**WILLIAMSON COUNTY, TEXAS**

**CHANGE ORDER**

For Project: **WILLIAMSON COUNTY JAIL KITCHEN & PLUMBING REMODEL**  
 Date of Issuance: 7/10/2018  
 Contractor: STR Constructors, LTD.  
 Project Engineer: Talex, Inc.

This change order is due to the following:  
 PCO #37r1 - SPT Kitchen Credit & Addt Connection

**P101**  
 SHEET

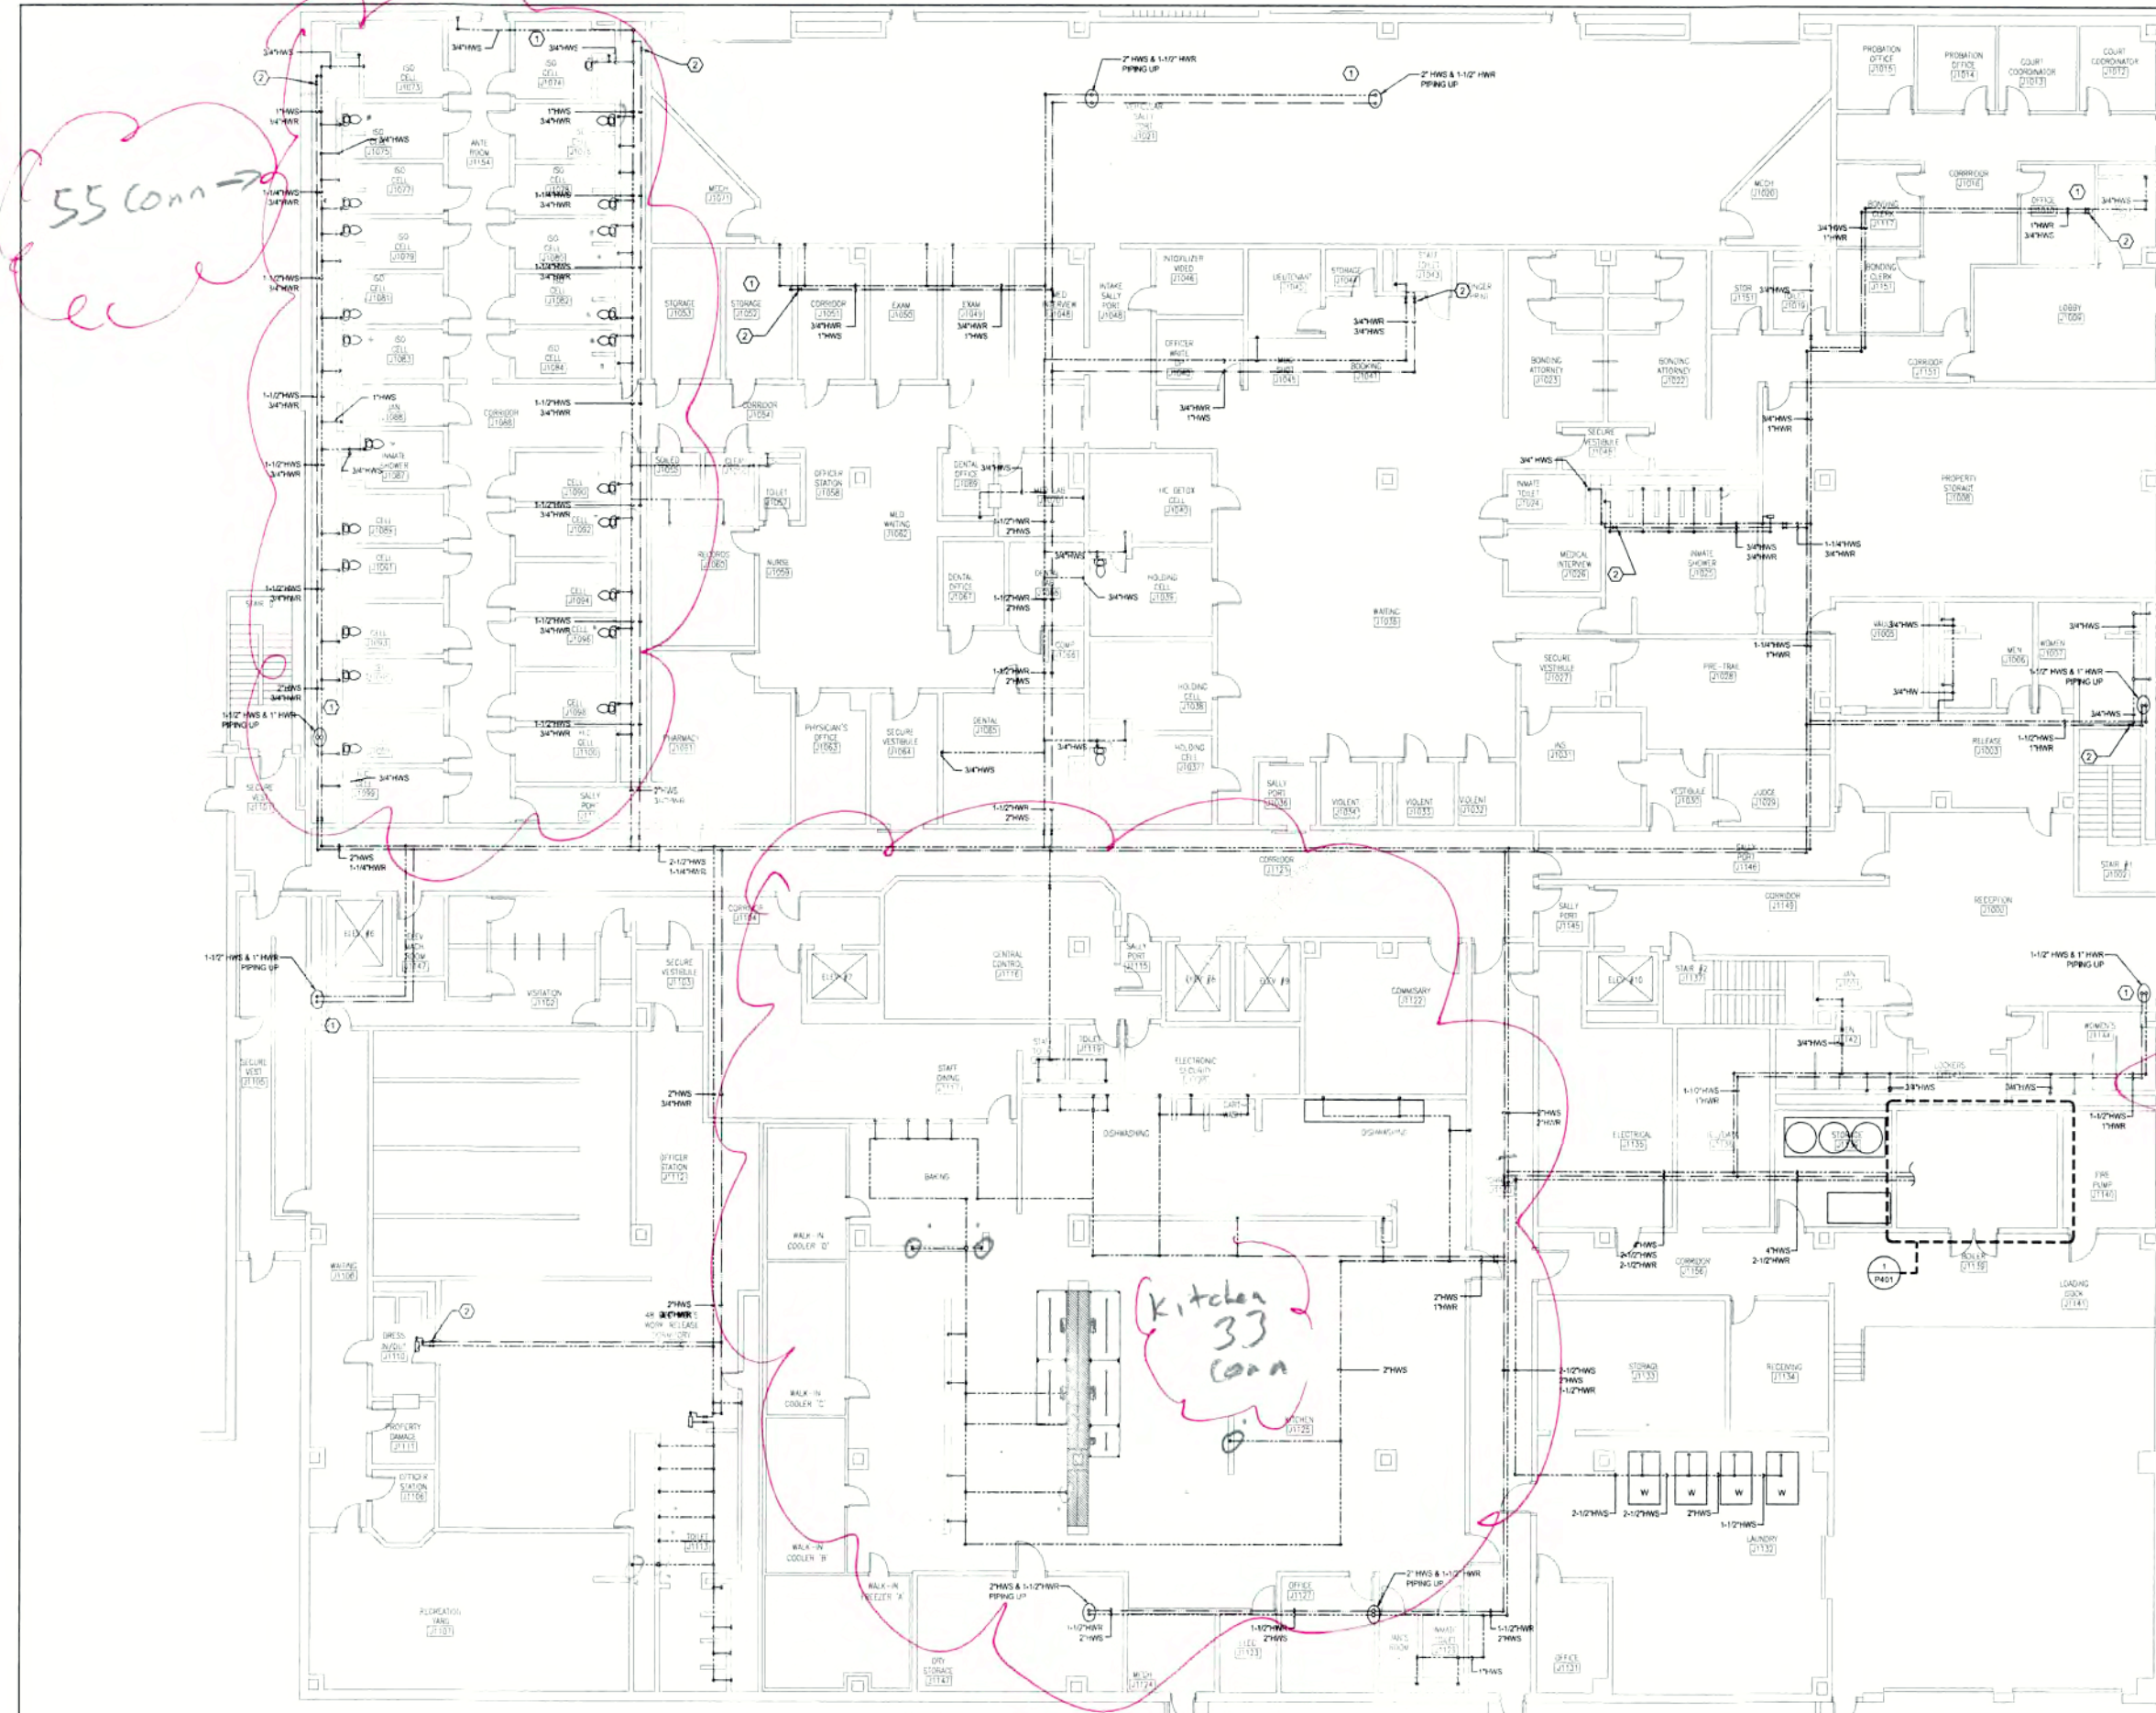
55 Conn →

55 Conn  
Restrooms

33 Conn  
Kitchen

88 Connection

Kitchen  
33  
Conn

**P102**

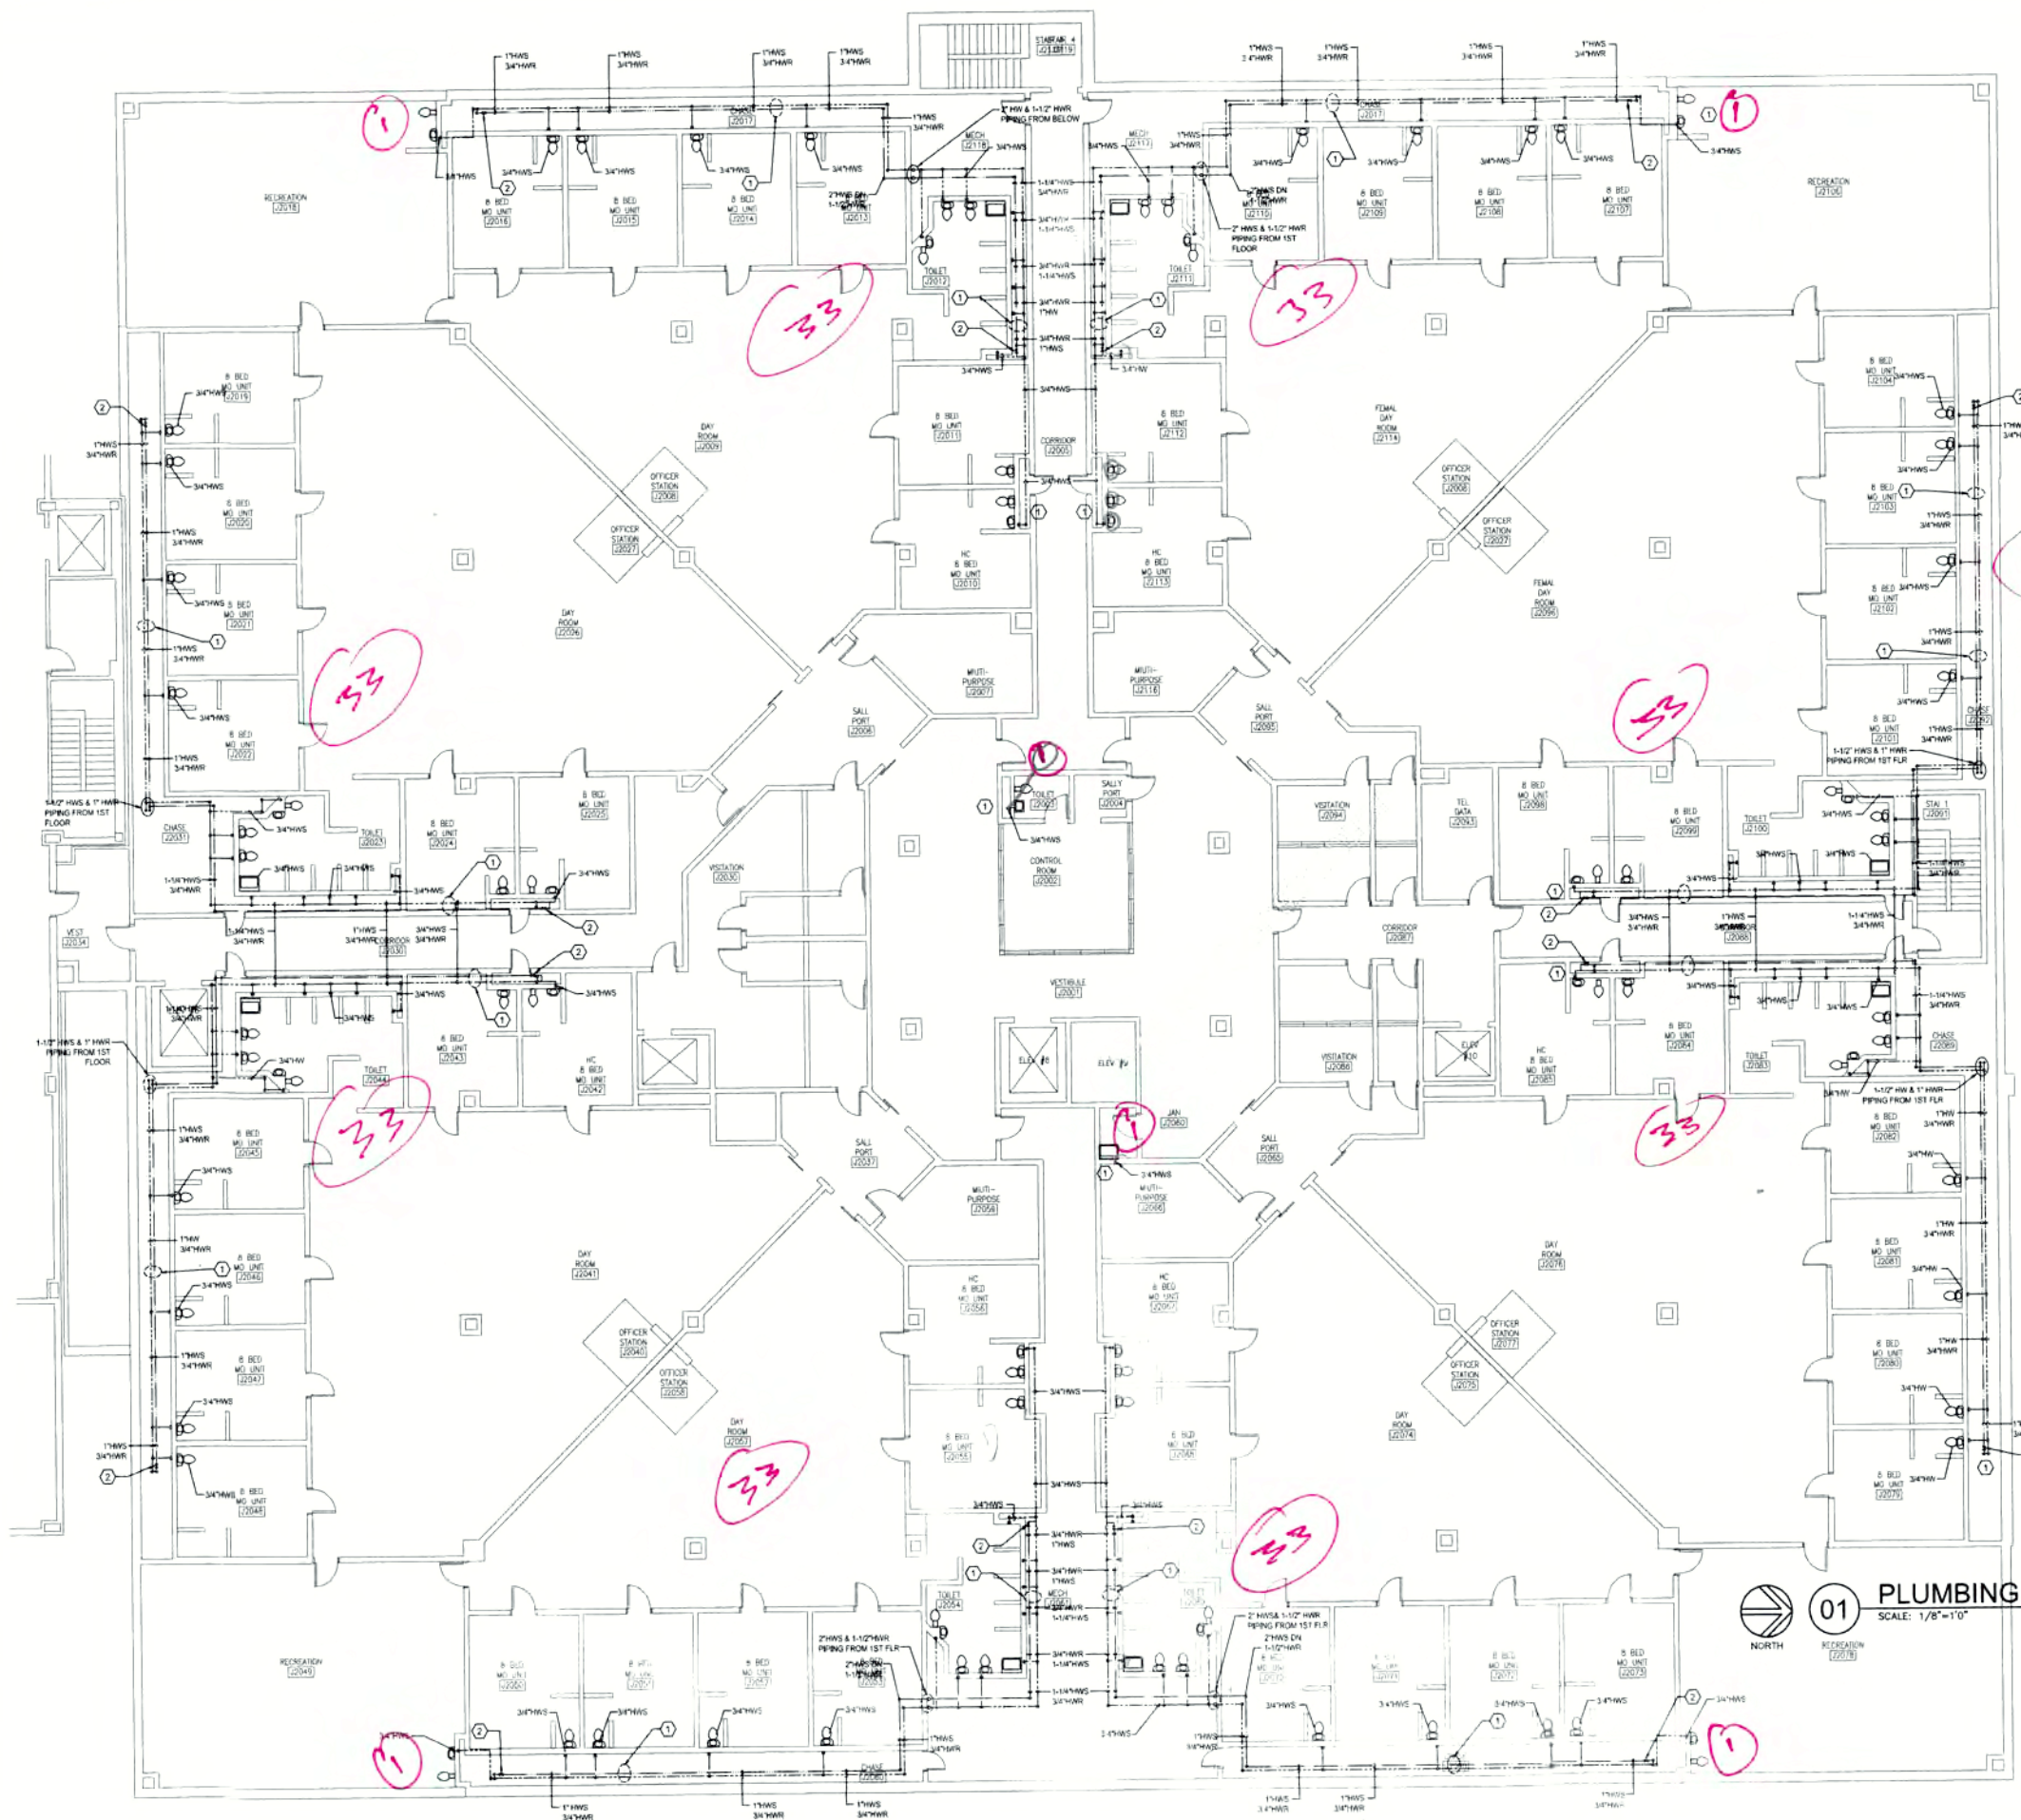
270 Connection  
 Pods

33 / Pod = 264

6 @ misc = 6

270

**P103**  
 SHEET

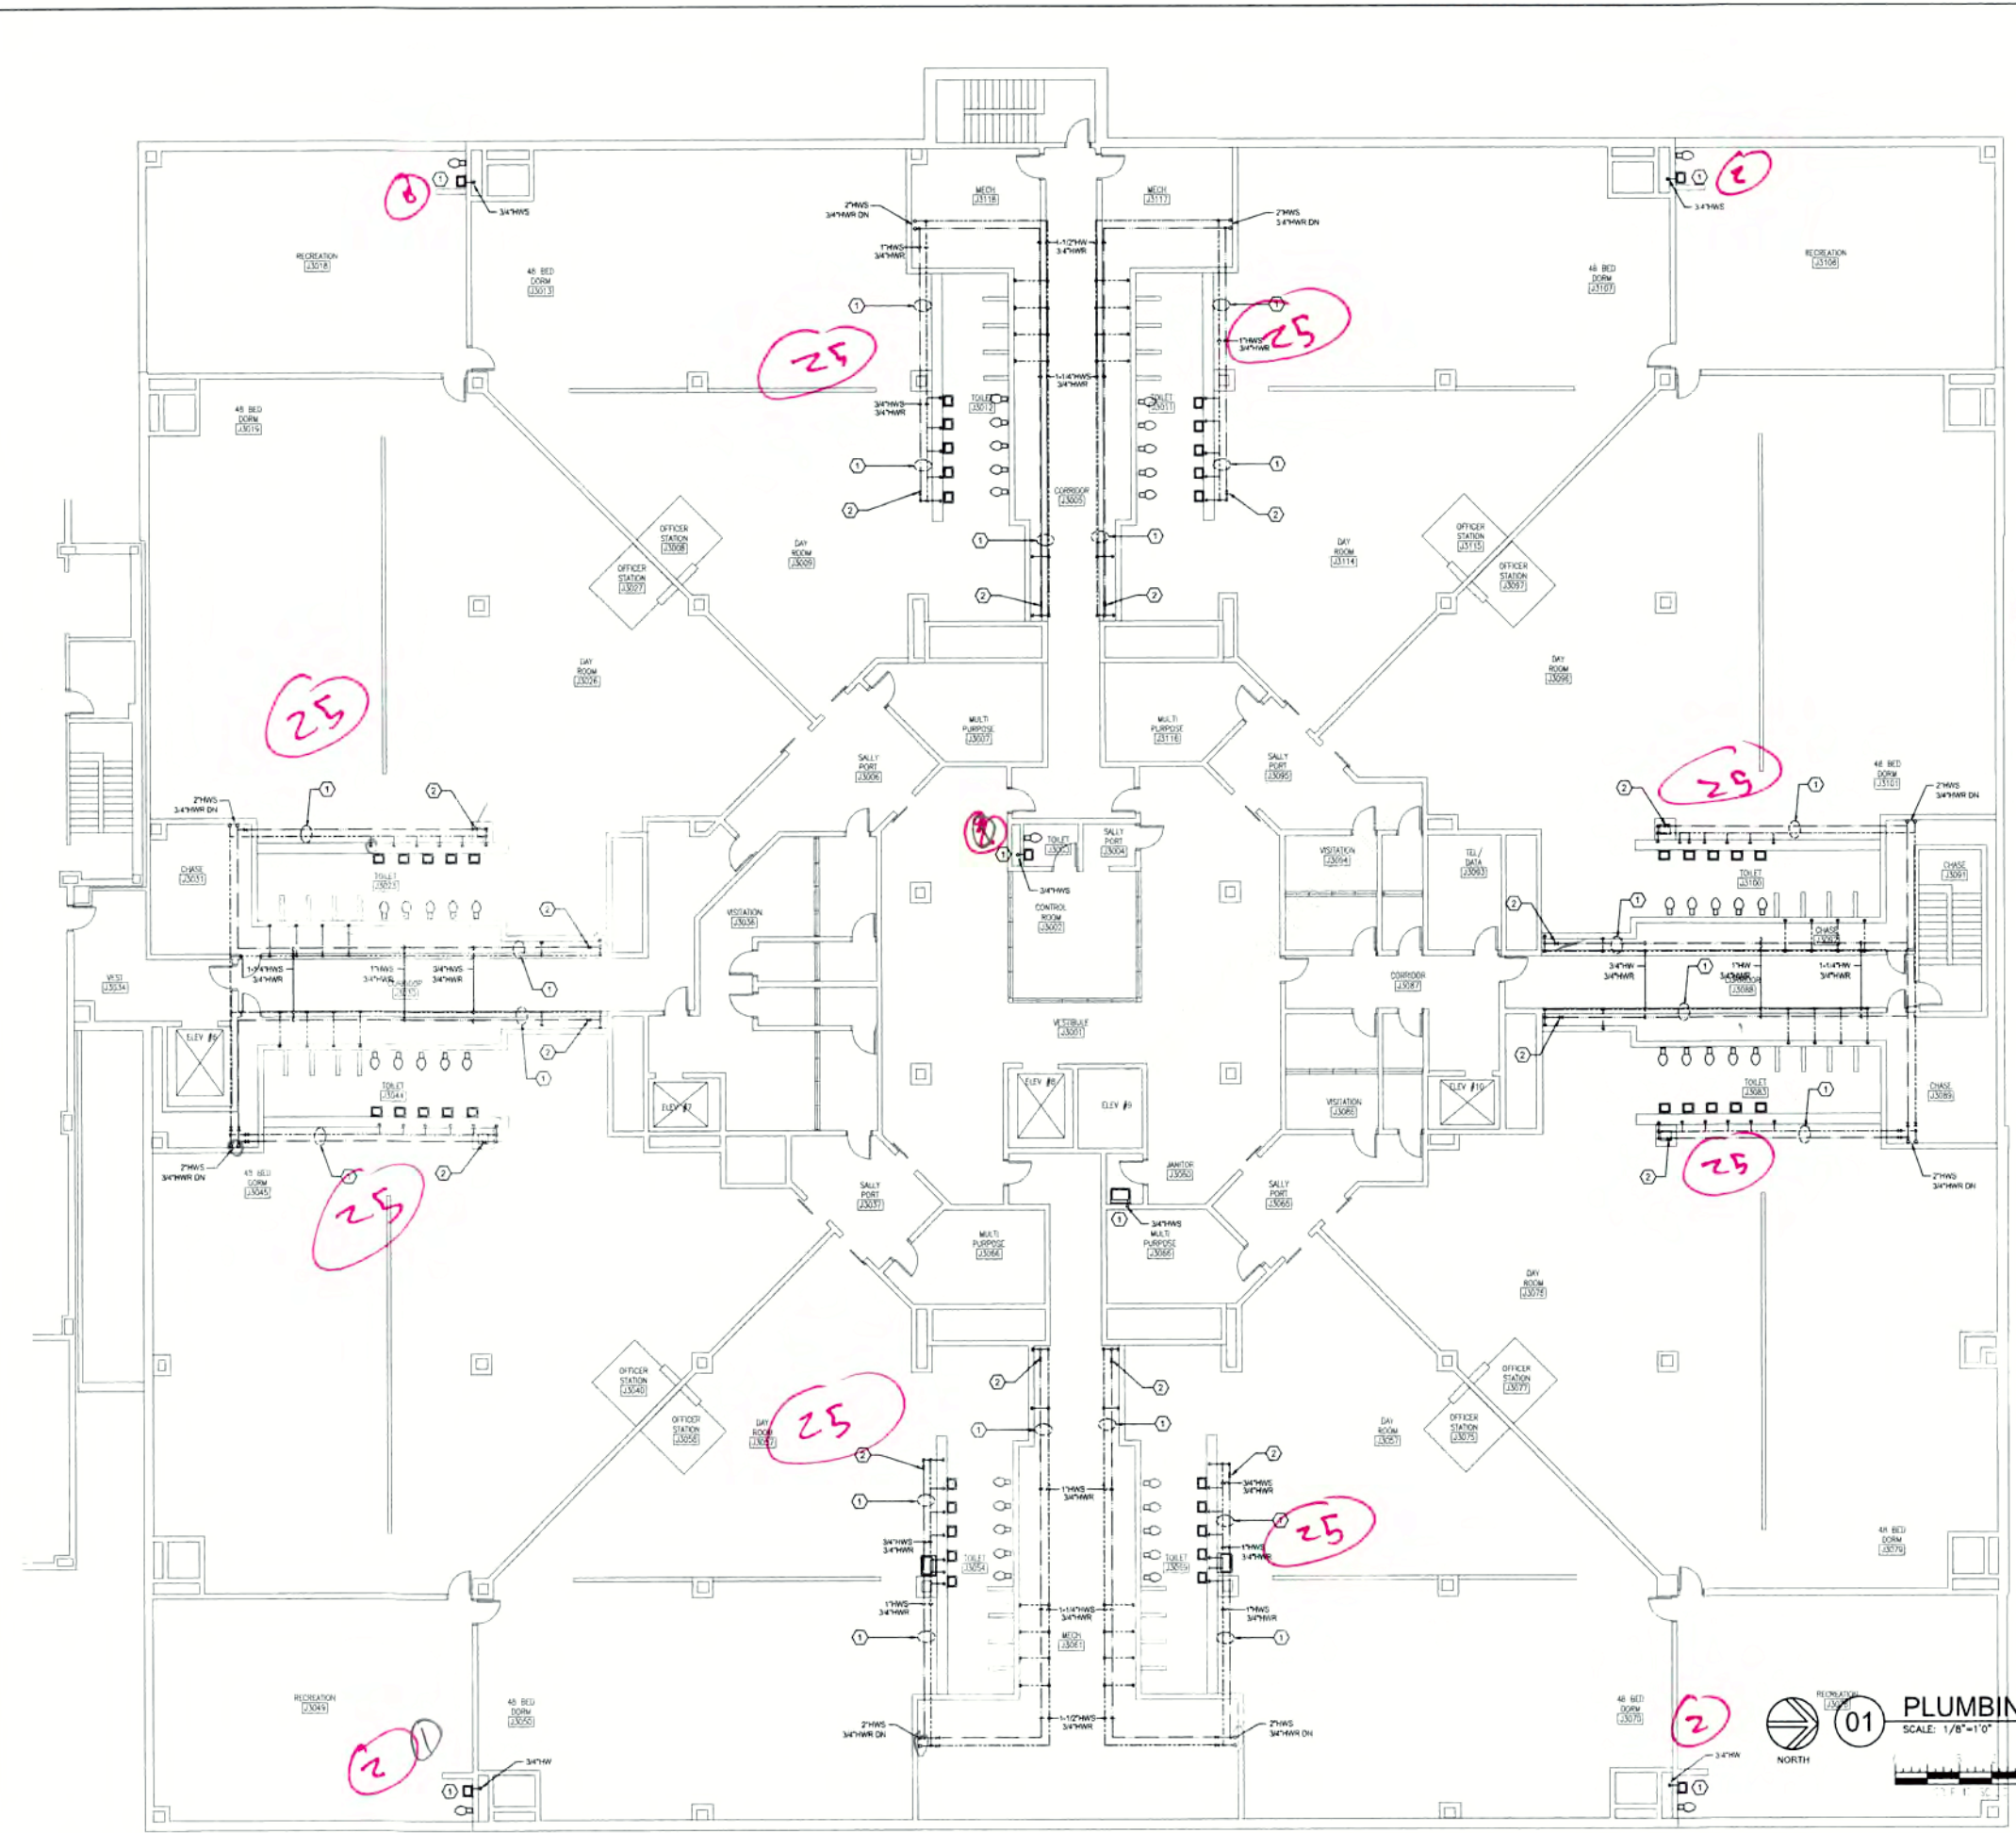
*210 Connection Pods*

*25 / Pod = 200*

*10 misc = 10*

*210*
